ADDENDUM #3

Virtual Service Center Job #49-22-PW October 6, 2022

Answers to questions asked at the voluntary pre-bid site walk:

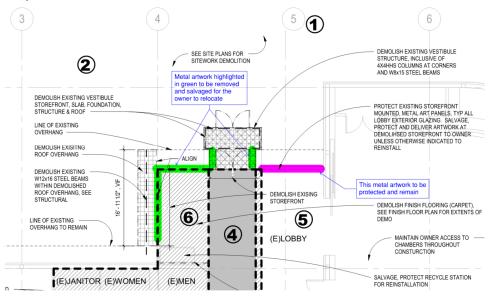
Q3: Will the contractor be responsible for removing and salvaging the existing metal art panels in the existing lobby?

Answer: Please refer to sheet A1.1 which describes how to handle the existing metal art panels. Snip from A1.1 with owner notes below:

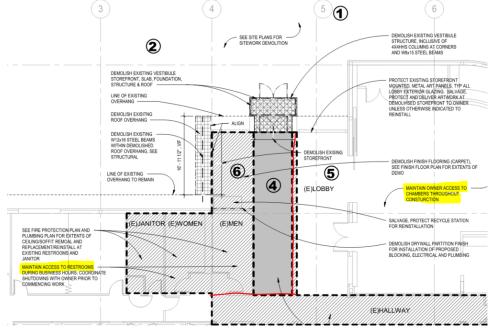
Q5: What is the plan for separating and protecting the existing City Hall lobby from the construction area?

Answer: Access to council chambers and restrooms to be maintained during construction. Contractor to coordinate any shutdowns with owner prior to commencing work. Protect existing City Hall lobby along red line on snip of A1.1 below:
